**VILLAGE OF GERMANTOWN**  
N112 W17001 MEQUON ROAD  
GERMANTOWN, WI 53022

| MEETING:       | <b>PLAN COMMISSION</b>                    |
| DATE AND TIME: | <b>MONDAY, AUGUST 14, 2017 6:30 p.m.</b>  |

# SITE PLAN REVIEW

**UTILITY PLAN**  
**PART OF THE SW 1/4 OF SECTION 21, T 9 N, R 20 E,**  
**VILLAGE OF GERMANTOWN, WASHINGTON COUNTY,**  
**WISCONSIN**

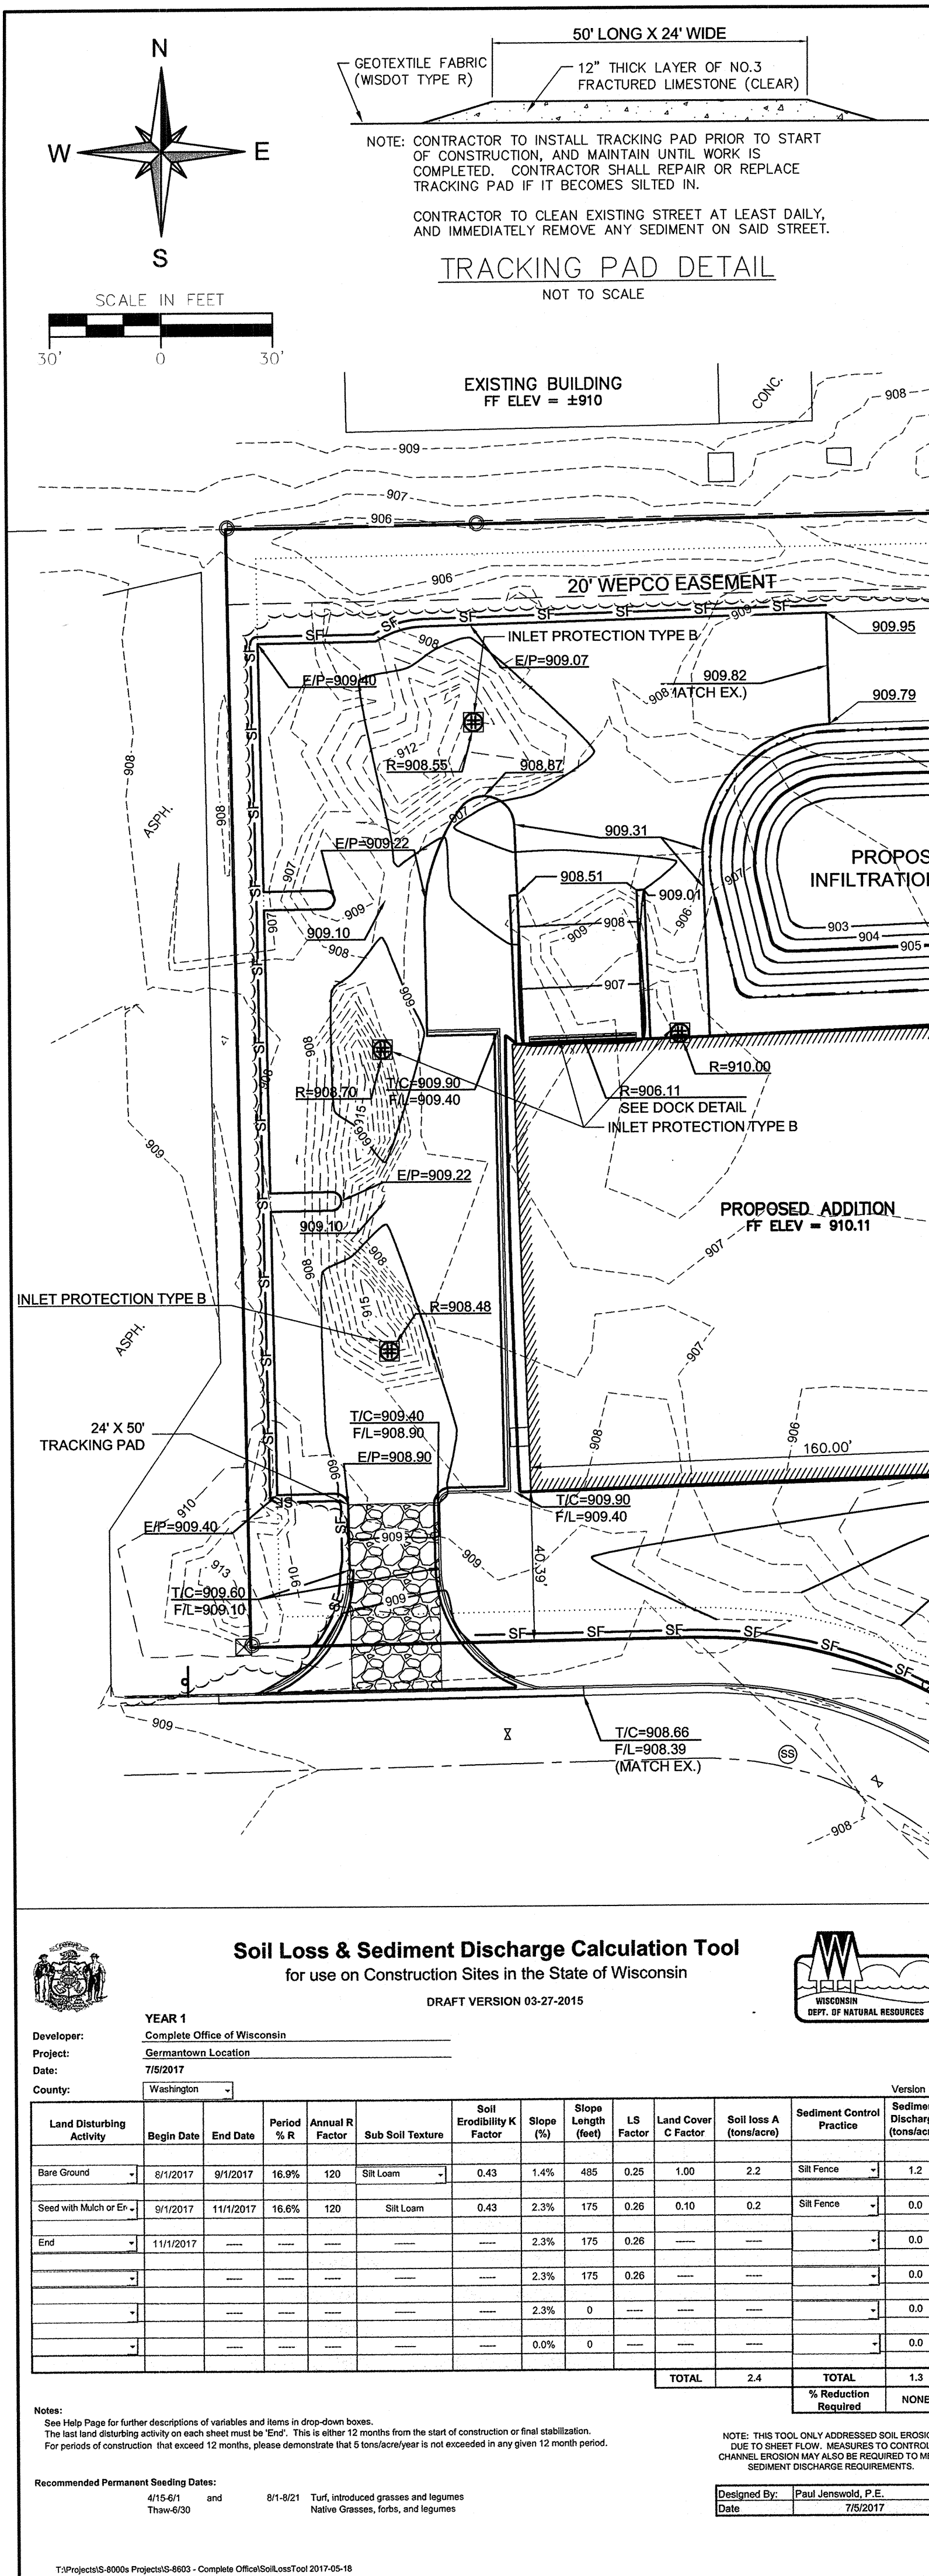
The Village Engineer has identified one issue that will need to be addressed prior to issuance of an occupancy permit (see copy of August 9, 2017 memo from Village Engineer John Laning) concerning needed improvements to the existing sampling manhole:

1. The sampling manhole for the property will require removal of the existing deck and replaced with a cone section and mac-wrapped. In addition, the bench inside of the sampling manhole will need to be re-worked as it is currently back pitched. The sampling manhole will also require installation of an internal/external Adaptor Inc. manhole seal and a Neenah R-1661 manhole frame with a solid bolt down lid with gasket.

LANDSCAPE PLAN

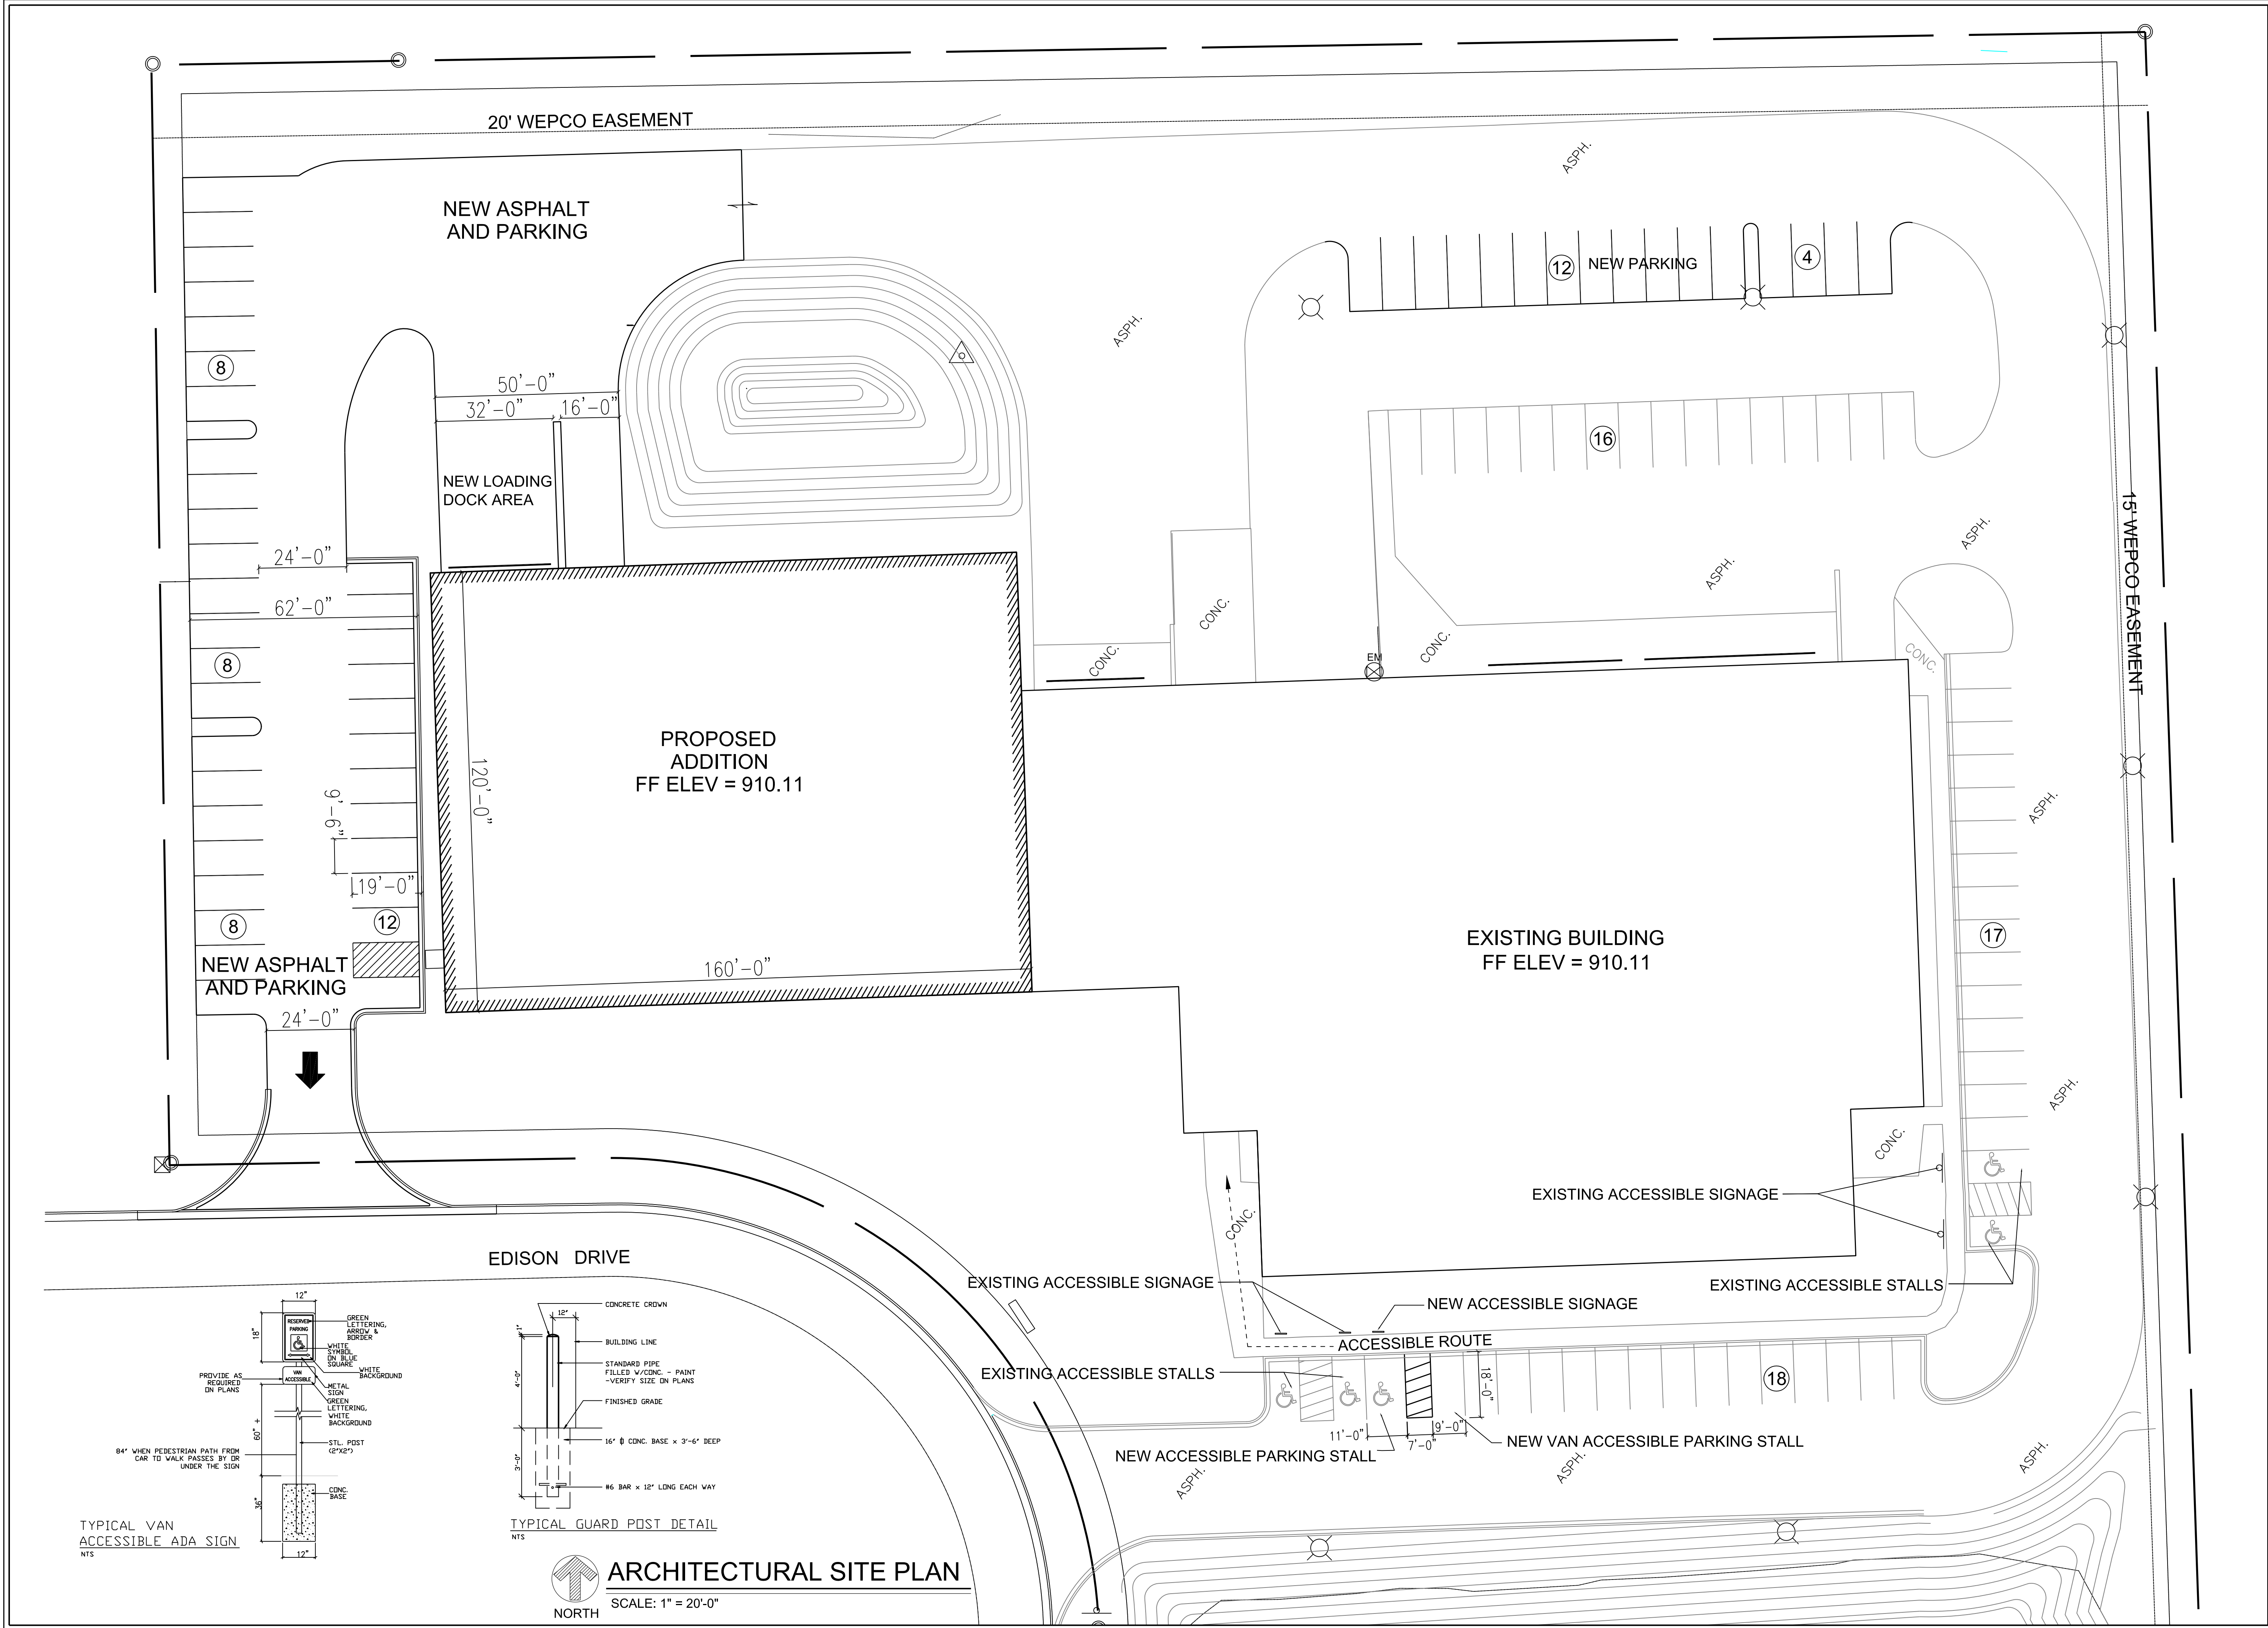
A large portion of the wooded area on the west side of the site in the location of the proposed building addition and parking area will be removed (a tree removal plan currently being prepared will identify those trees that are intended to be saved). However, in so doing, some of the trees that might ordinarily have satisfied the Village's street tree requirement may be removed and, as a result, will need to be replaced in order to meet the street tree requirements. Staff recommends that the landscape plan be revised to include street trees along Edison Drive, either by: (1) showing which existing deciduous trees will be maintained (provided that such trees are located within 30 feet from the road right-of-way); or, by adding street trees in an amount equal to (1) tree per 40-50 feet of road frontage. Said trees need to be listed as an acceptable species and installed in accordance with the Village's Street Tree Guidelines. Said trees may be planted in decorative clusters and not necessarily evenly space along the road frontage.

3. The Owner shall revise the proposed landscaping plan to include street trees along Edison Drive, either by: (1) showing which existing deciduous trees will be maintained (provided that such trees are located within 30 feet from the road right-of-way); or (2) by adding street trees to the plan in an amount equal to (1) tree per 40-50 feet of road frontage. Said street shall be a minimum 3" caliper and need to be listed as an acceptable species and installed in accordance with the Village's Street Tree Guidelines. Said trees may be planted in decorative clusters and not necessarily evenly space along the road frontage. Said revised plan shall be submitted to the Village Planner for review/approval prior to issuance of a building permit.
